RS-10-039
June 4, 2010

Clinton Power Station, Unit 1
Facility Operating License No. NPF-62
NRC Docket No. 50-461

Subject: License Amendment Request to Administratively Revise Technical Specifications

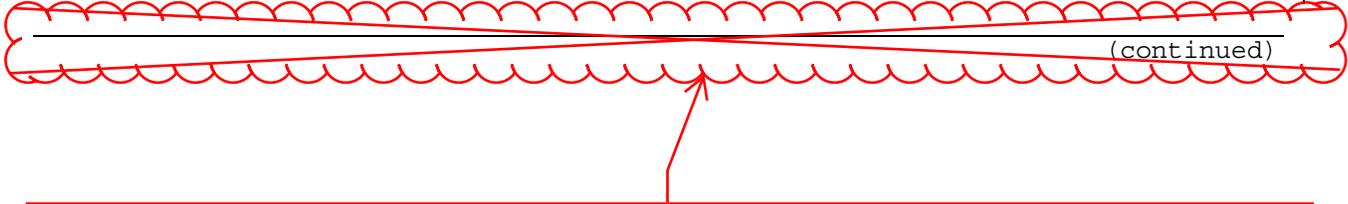
Correct an administrative issue in TS 3.0, "SR Applicability," Page 3.0-5. The proposed change corrects an editorial issue related to the format of page 3.0-5. The proposed change removes the single line and parenthetical "(continued)" at the bottom of Page 3.0-5, and inserts a double line to indicate the end of the section. This administrative error was introduced into the TS during the implementation of Amendment 163 (Reference 1).
